Tennessee Valley Authority, Post Office Box 2000, Decatur, Alabama 35609-2000

BROWNS FERRY NUCLEAR PLANT (BFN) - UNITS 2 AND 3 - TECHNICAL SPECIFICATIONS (TS) CHANGE TS-418 - REQUEST FOR EXTENDED POWER UPRATE OPERATION- RESPONSE TO NRC REQUESTS FOR ADDITIONAL INFORMATION REGARDING CREDIT FOR CONTAINMENT OVERPRESSURE (TAC NOS. MC3743 AND MC3744)

TENNESSEE VALLEY AUTHORITY
BROWNS FERRY NUCLEAR PLANT (BFN)
UNITS 2 AND 3

RESPONSE TO QUESTION SPSB-A.11
FROM NRC LETTER DATED OCTOBER 3, 2005

FIGURE SPSB-A.11-1: NPSH REQUIREMENTS FOR DBA LOCA - SHORT TERM

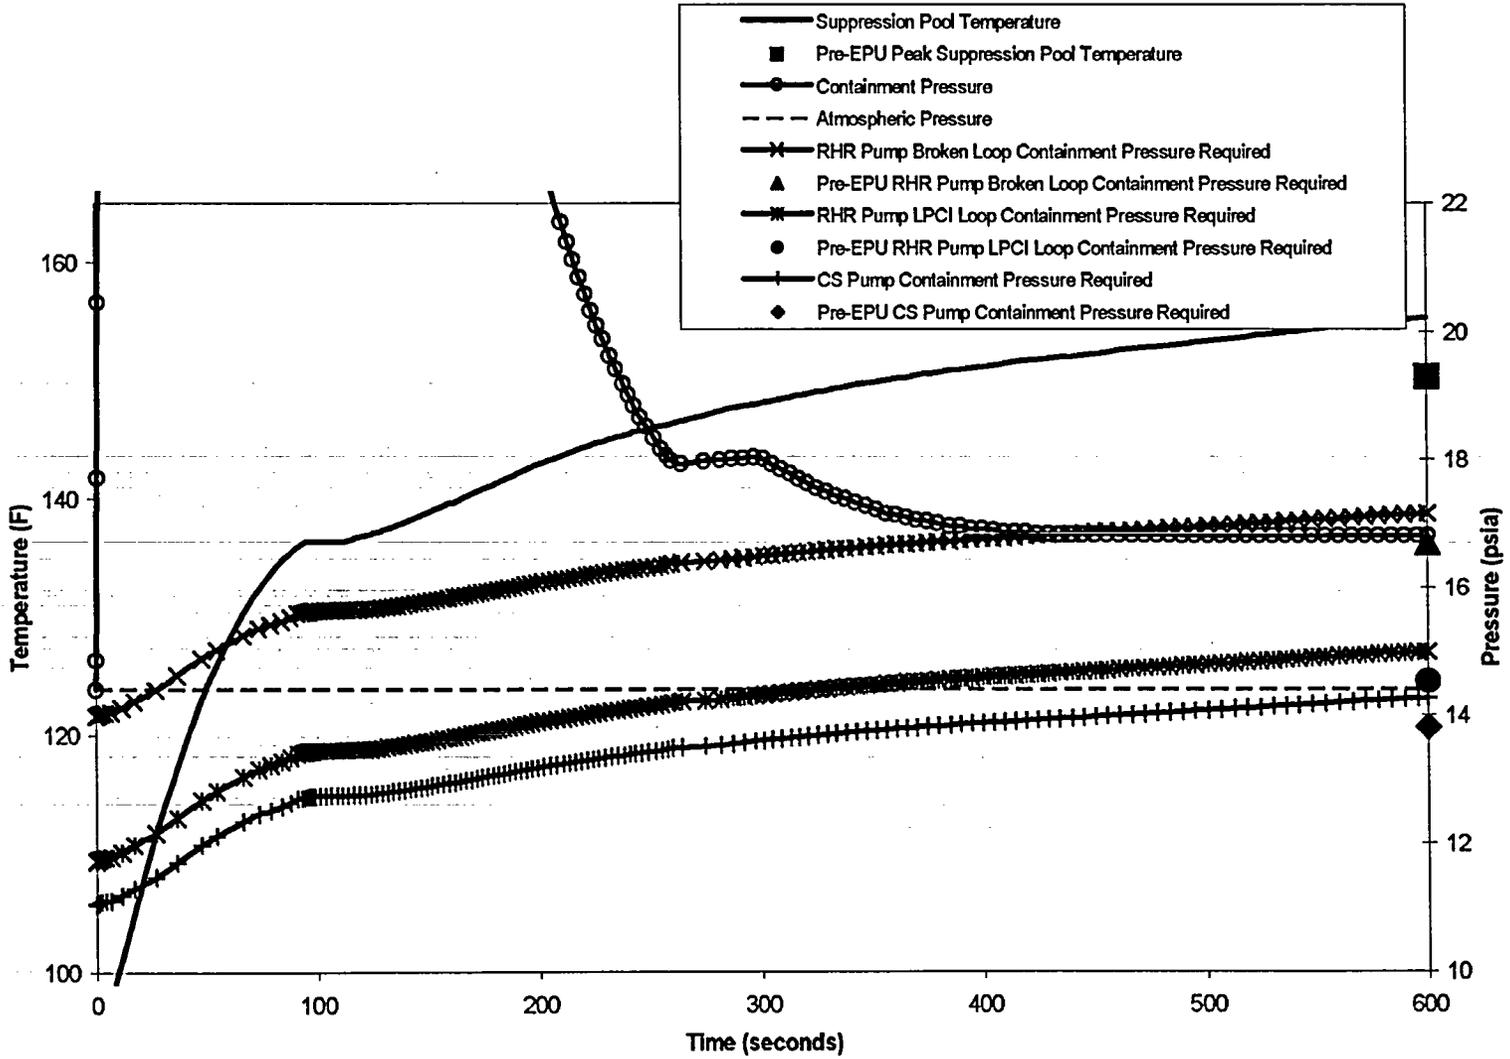
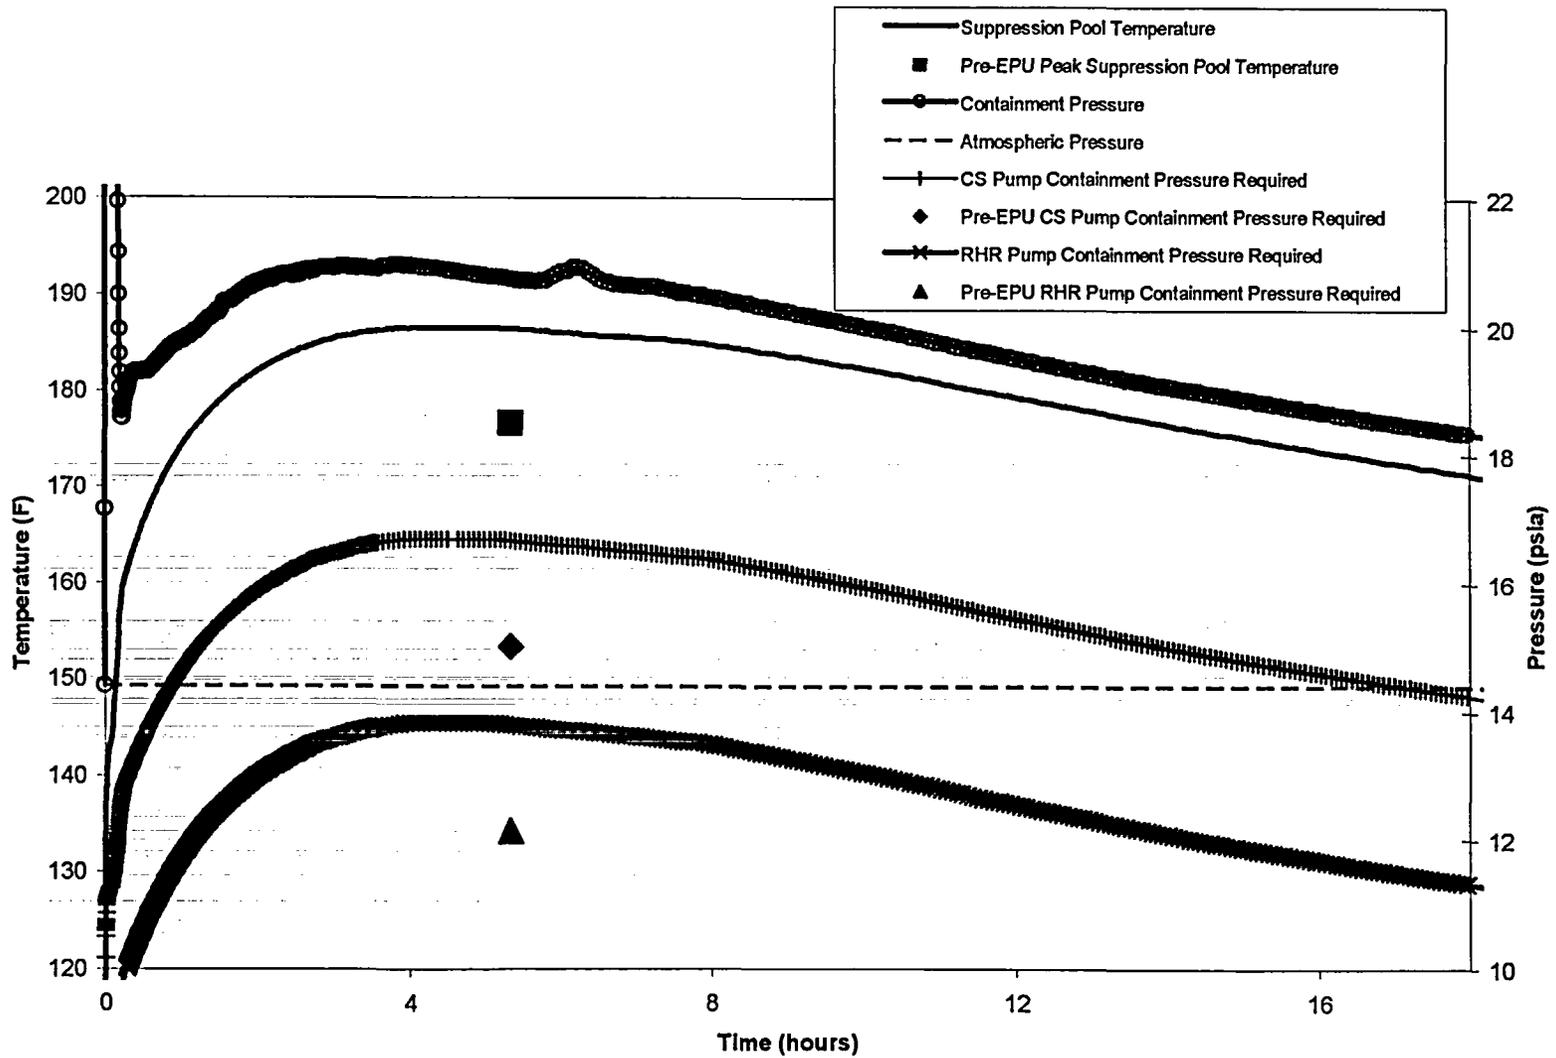
Considering the above discussion, please provide an assessment of the credit for containment accident pressure against the five key principles of risk-informed decision making stated in RG 1.174 and SRP Chapter 19. Specifically, demonstrate that the proposed containment accident pressure credit meets current regulations, is consistent with the defense-in-depth philosophy, maintains sufficient safety margins, results in an increase in core-damage frequency and risk that is small and consistent with the intent of the Commission's Safety Goal Policy Statement, and will be monitored using performance measurement strategies. With respect to the fourth key principle (small increase in risk), provide a quantitative risk assessment that demonstrates that the proposed containment accident pressure credit meets the numerical risk acceptance guidelines in Section 2.2.4 of RG 1.174. This quantitative risk assessment must include specific containment failure mechanisms (e.g., liner failures, penetration failures, primary containment isolation system failures) that cause a loss of containment pressure and subsequent loss of NPSH to the ECCS pumps.

The bounding design basis event for determining NPSH margin is a double ended recirculation discharge line break. This event results in maximum suppression pool temperature and maximum total pump flow. The discharge line break is chosen because the low system resistance on the broken line produces the most limiting flow and NPSH for two RHR pumps which are assumed to be pumping into the broken line inside containment. At the beginning of the event, four RHR pumps and four CS pumps start automatically and align to inject to the Reactor Pressure Vessel (RPV). Two RHR pumps inject to the RPV at 10,000 gpm each, two RHR pumps inject through the broken line into the containment at 11,000 gpm each (greater than design flow), and four CS pumps inject to the RPV at 3,125 gpm each. This mode of operation is assumed for 10 minutes consistent with not crediting operator action for 10 minutes. ECCS strainers are assumed to accumulate the maximum equilibrium debris load. During this time, suppression pool temperature reaches 155.4°F, and only the RHR pumps require credit for COP in order to have sufficient NPSH margin as shown in Figure SPSB-A.11-1.

At 10 minutes, operator action is assumed which places the minimum complement of ECCS pumps into modes required for long-term cooling. Two CS pumps (one loop) at design flow of 3,125 gpm each are assumed for core cooling, and two RHR pumps (one loop in containment cooling mode) at 6,500 gpm each are assumed for pool cooling. Containment spray mode of containment cooling is chosen to minimize available containment pressure. Only two of four RHR pumps are assumed for pool cooling due to single failure considerations. ECCS strainers are assumed to accumulate the maximum equilibrium debris load. During this time, suppression pool temperature reaches 187.4°F, and only the two CS pumps require credit for COP in order to have sufficient NPSH margin as shown in Figure SPSB-A.11-2.

By comparison to the RHR pumps, the CS pumps would be challenged in the long-term scenario in the event that COP was lost. CS pumps do not require COP in the short-term (Refer to Figure SPSB-A.11-1). BFN CS pumps are Sulzer-Bingham model 12x16x14.5 CVDS. Assuming no credit for COP, the CS pumps used for long-term core cooling (>10 minutes) would be expected to operate between 27 feet and 21.2 feet of NPSH verses 27 feet used in NPSH calculations for approximately 17.1 hours as suppression pool temperature peaks above 171°F during the LOCA. In the unlikely event they become degraded, there is a reasonable likelihood that the affected pumps would still be able to function. In addition, only one of the two CS loops is required to be operated for adequate core cooling and the non-operating CS loop would be available to operators if the operating loop failed after some time period. RHR pumps would also be available in the LPCI mode for core cooling in conjunction with their suppression pool cooling function should all CS pumps become unavailable. COP is not required for RHR pumps in the long-term scenario. Therefore, in the unlikely event that COP was lost in the long-term LOCA, the decay heat removal and core cooling functions would be maintained.
